TECHNICAL MEMORANDUM

Subject: Treatability/Pilot Study Modification No. 2 – Las Vegas Wash Bioremediation Pilot Study
Nevada Environmental Response Trust Site, Henderson, Nevada

TREATABILITY/PILOT STUDY MODIFICATION NO. 2 -
LAS VEGAS WASH BIOREMEDIATION PILOT STUDY

PROPOSED LOCATIONS FOR ADDITIONAL INVESTIGATION
TRANSECT 1B VICINITY

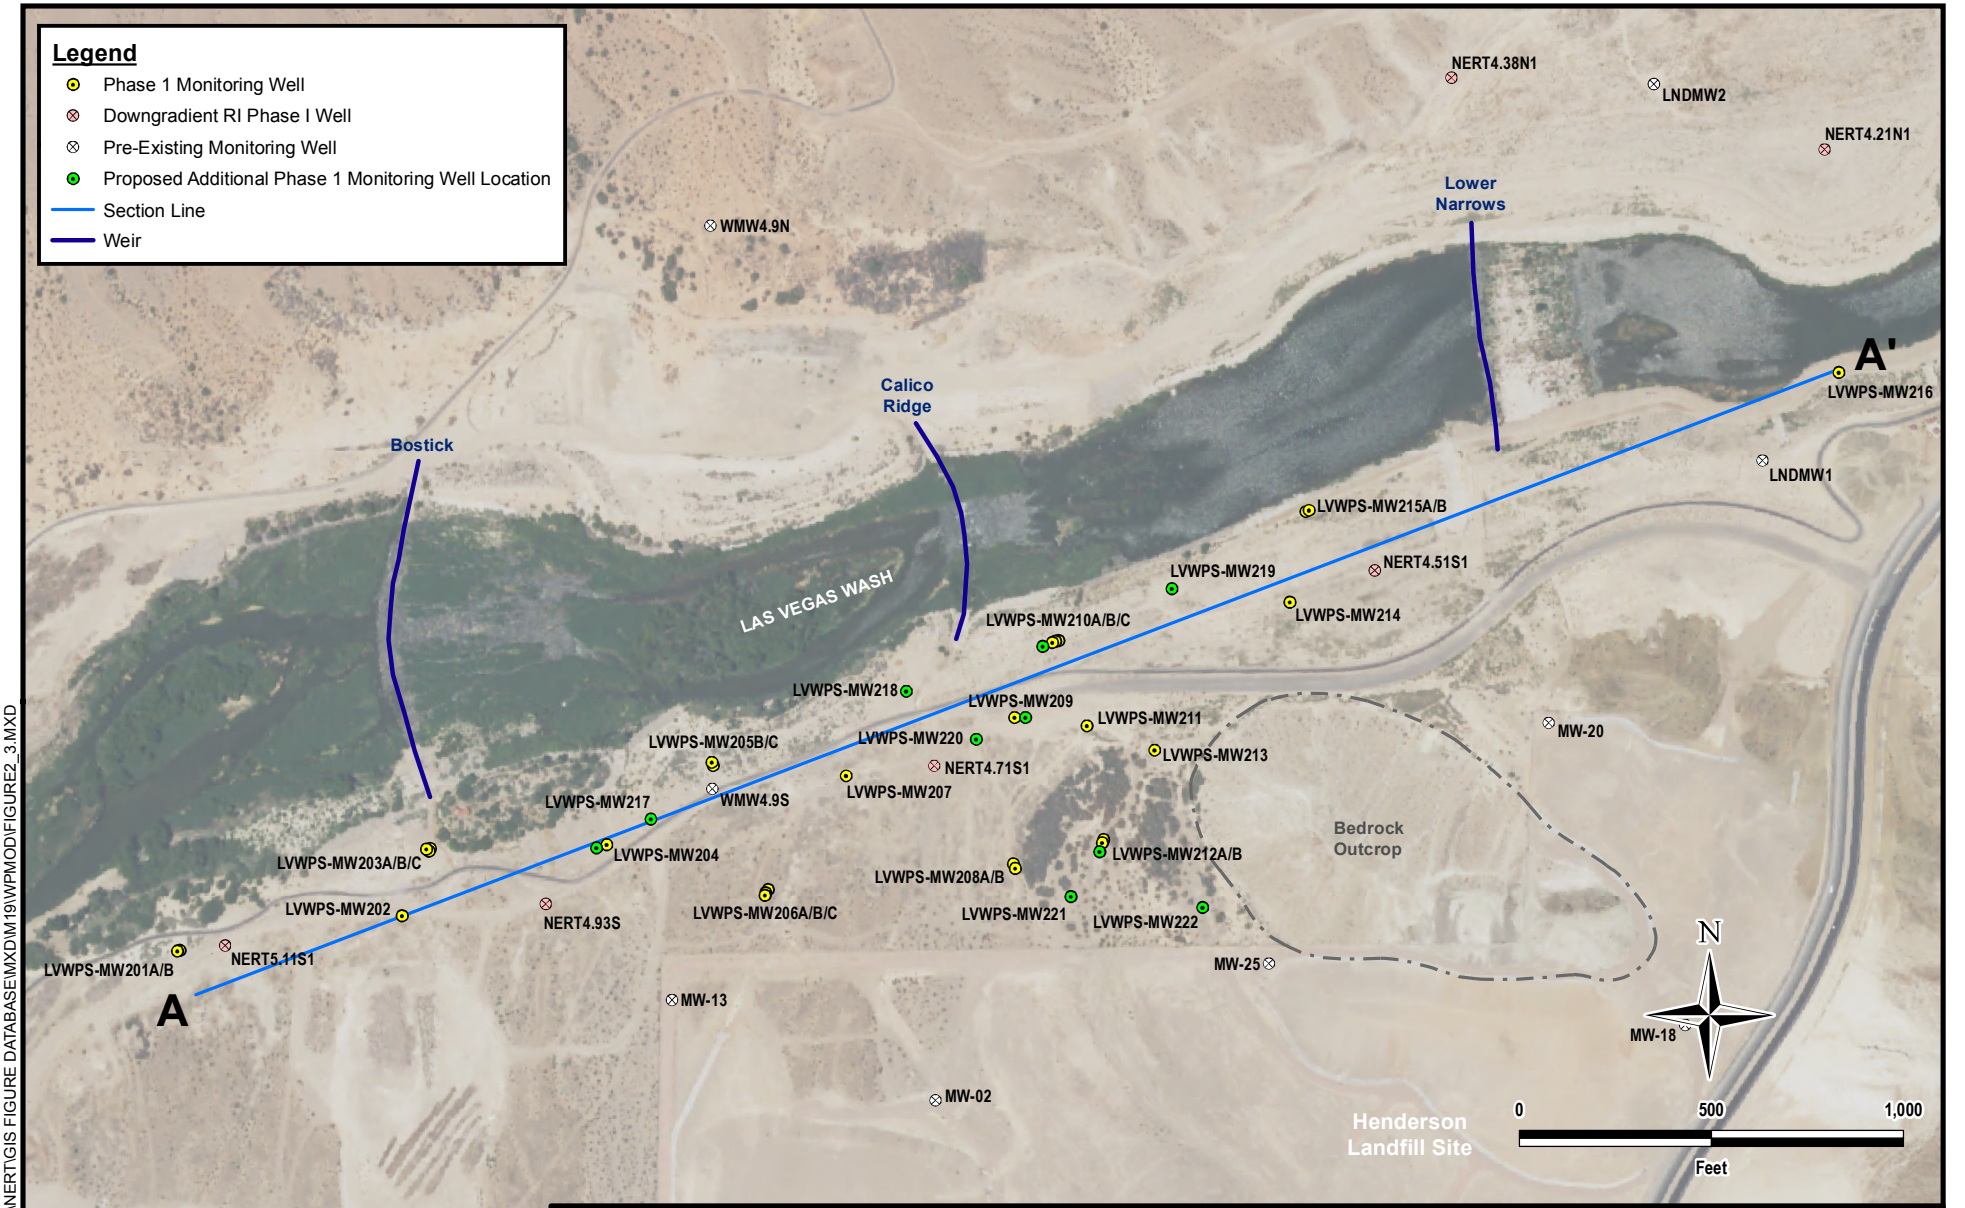
Based on these observed deep perchlorate detections and evidence of paleochannels, Tetra Tech recommends modifying the scope of work for the current Phase 1 activities associated with the Las Vegas Wash Bioremediation Pilot Study. Additional investigation is recommended to further delineate the vertical distribution of perchlorate contamination in the subsurface in both soil and groundwater and confirm details of this complex geologic/hydrogeologic setting. Four existing locations and six new locations are proposed for additional investigation. The following table presents a summary of each boring location presented in geographical order from west to east as identified on Figure 2.

LVWPS-MW217	<p>Because the highest soil perchlorate concentration of 10 mg/kg was detected at 120 feet bgs at location LVWPS-MW204, an additional location (LVWPS-MW217) is proposed to the east of LVWPS-MW204 to evaluate the spatial distribution of perchlorate contamination in the vicinity of LVWPS-MW204 and LVWPS-MW205. Data collected may provide additional information to delineate the geometry of the alluvial channel at LVWPS-MW205 (Figure 3).</p>	250 ft; 10 ft intervals from top of the water table to 250 ft
-------------	--	---

Proposed Location	Justification	Total Depth; Soil Sampling Interval
LVWPS-MW218	A new location is proposed to the west of the highest perchlorate concentration detected in groundwater collected from the deepest well within the LVWPS-MW210 cluster. Data collected from this location will be used to evaluate the spatial distribution of perchlorate contamination in the vicinity of LVWPS-MW210 and geometry of the deep alluvial channel present within this vicinity.	250 ft; 10 ft intervals from top of the water table to 250 ft
LVWPS-MW220	New location LVWPS-MW220 is proposed west of LVWPS-MW209 to further evaluate the morphology of the deep alluvial channel encountered at LVWPS-MW209 and the depth of elevated perchlorate concentrations.	250 ft; 10 ft intervals from top of the water table to 250 ft
LVWPS-MW221	New location LVWPS-MW221 is proposed southwest of LVWPS-MW212 to further evaluate the spatial distribution of perchlorate contamination in the vicinity of LVWPS-MW212, where perchlorate concentrations increased with depth.	250 ft; 10 ft intervals from top of the water table to 250 ft

LVWPS-MW222	New location LVWPS-MW222 is proposed southeast of LVWPS-MW212 to further evaluate the spatial distribution of perchlorate contamination where perchlorate concentrations increased with depth. Furthermore, LVWPS-MW222 is adjacent to the bedrock outcrop and may provide valuable information to delineate the geometry of the faulting associated with the deep alluvial channel west of the bedrock outcrop.	250 ft; 10 ft intervals from top of the water table to 250 ft
LVWPS-MW219	A new location is proposed to the east of the highest perchlorate concentration detected in groundwater collected from the deepest well within the LVWPS-MW210 cluster. Data collected from this location will be used to evaluate the spatial distribution of perchlorate contamination in the vicinity of LVWPS-MW210 and the geometry of the deep alluvial channel in this vicinity.	250 ft; 10 ft intervals from top of the water table to 250 ft

As part of this proposed modification, the first soil boring at each location will be advanced to a depth of up to 250 feet bgs. If bedrock is encountered prior to reaching 250 feet bgs, then the boring will be advanced up to 15 feet into bedrock to evaluate its characteristics. If cemented or consolidated UMCf is encountered prior to reaching 250 feet bgs, the boring will be advanced to the shallower of 250 feet or up to 50 feet into the consolidated UMCf and then terminated.

During this additional investigation, soil samples will be collected on approximate 10-foot intervals from the top of the water table to the bottom of the boring and analyzed for perchlorate at each of the six new locations. At the four existing locations, soil samples will be collected starting at 130 feet bgs and will continue to be collected on approximate 10-foot intervals to 250-foot bgs, as soil samples were already collected during Phase 1 activities to a depth of 120 feet. Soil samples will be sent to Test America for perchlorate analysis on a 24-hour turnaround to provide as close to real-time data as possible that will be used to make field decisions thus allowing the field effort described herein to be completed within a single mobilization. Upon completion of the first boring (at either of the
